Grimes City Council Agenda

Grimes City Council Meeting June 22, 2021 In Person/Zoom at Grimes Community Center, 410 SE Main Street

- E. Crossroads Plat 4, Preliminary Plat
- F. Crossroads Plat 4 Site Plan
- G. Report and Status Update on Water Distribution

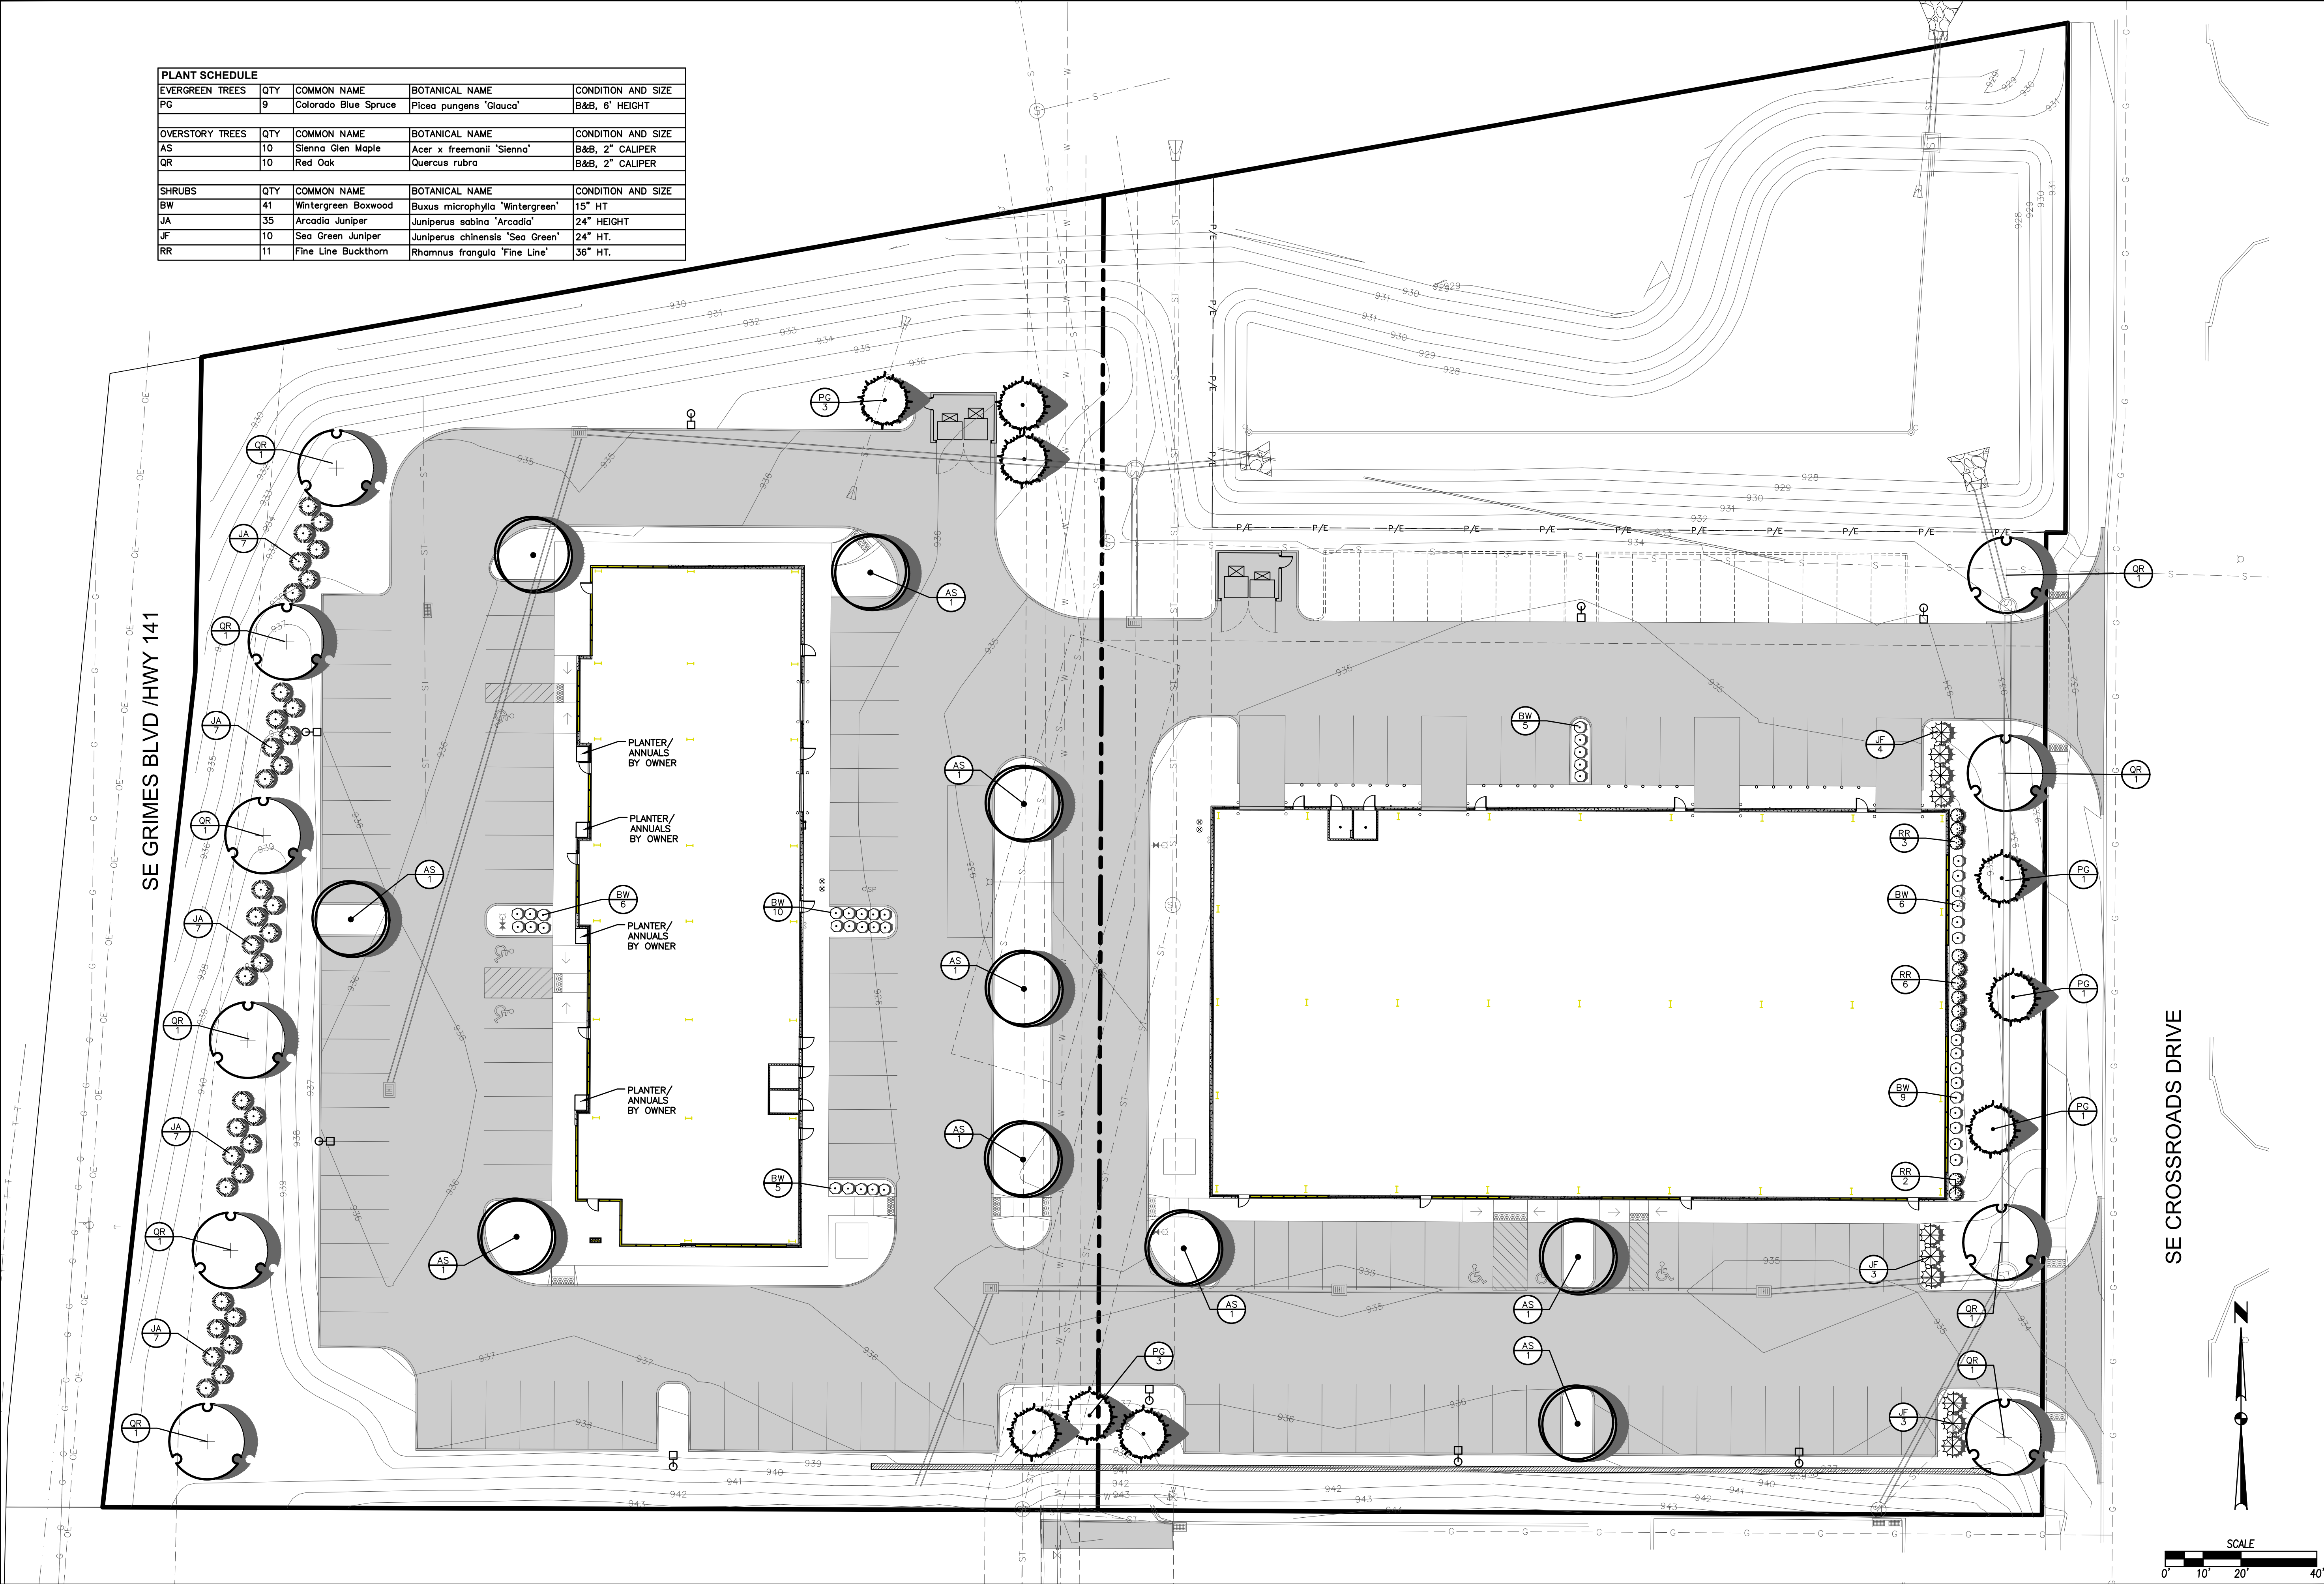
6. **If sanitary connections are taps utilize Romac saddle or approved equivalent.**
7. **Will 6" storm lines L-4 & L-5 be perforated? Will they be bedded in pea rock? Install sod after installation (Note 4 Sheet C2.0) is complete to prevent silt into trench plugging drain.**

- ~~1. C5.0: Provide emergency overflow and protection on basin.~~
- ~~2. C7.0: Provide detail for ST-2 and perforated riser.~~
- ~~3. C7.0: Do buildings require roof drain connections?~~
- ~~4. C7.0: How will the DA going to the future parking expansion be captured?~~
5. C5.0 & C9.1: Label basin as bioretention pond and provide cross-sectional detail of basin layers.
